Freightliner
Service Bulletin

49-27

Exhaust Stack Clamp Failure, EPA07 Vertical ATD

Fig. 1, Exhaust Clamp Installation

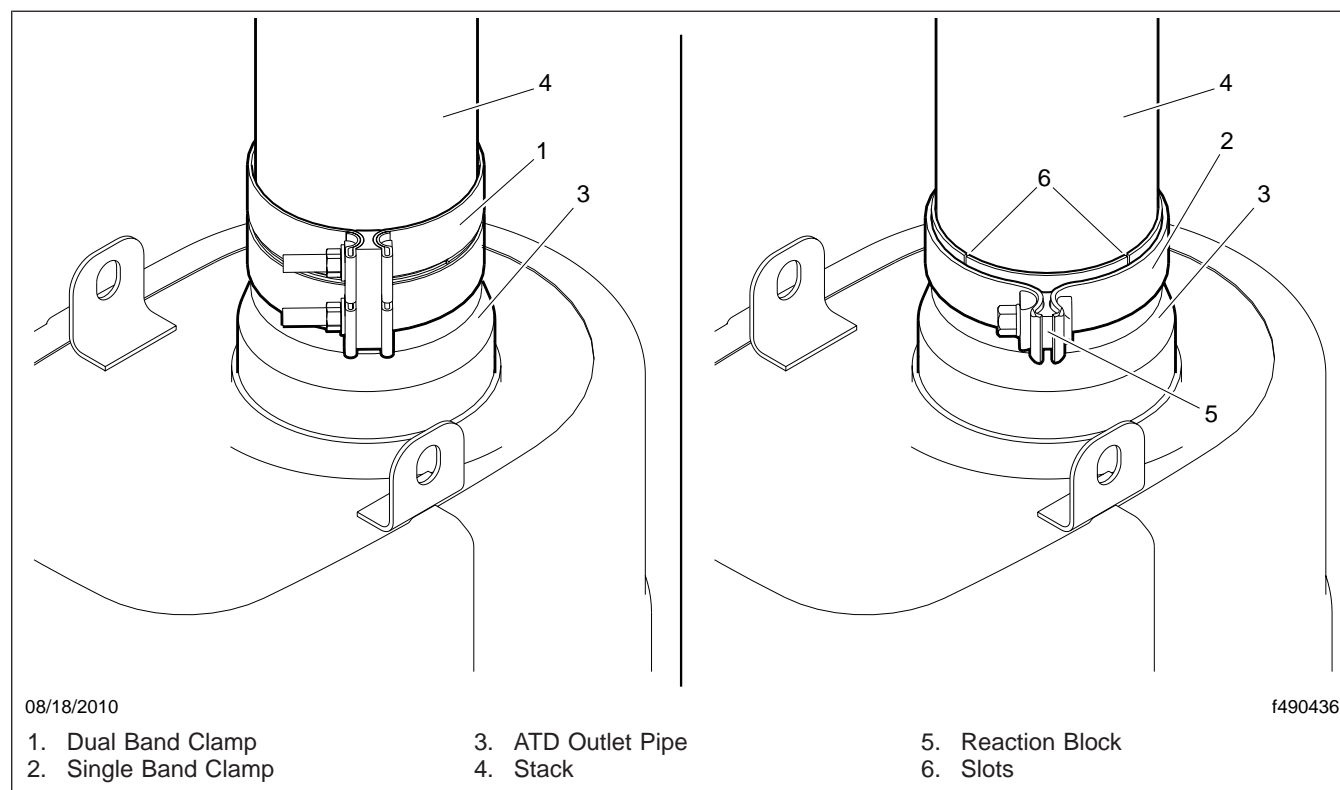
If a dual band exhaust stack clamp, part number 04-20289-000, fails on an EPA07 vehicle with a vertical ATD, replace it with single band clamp part number 04-29313-500. See [Fig. 1](#).

1. Remove the failed clamp.
2. Verify that the exhaust stack is clocked to 45 degrees.
3. Install the new clamp flush with the top of the ATD outlet pipe and with the reaction block centered between the slots in the outlet pipe. Tighten 35 to 47 lbf·ft (47 to 64 N·m).
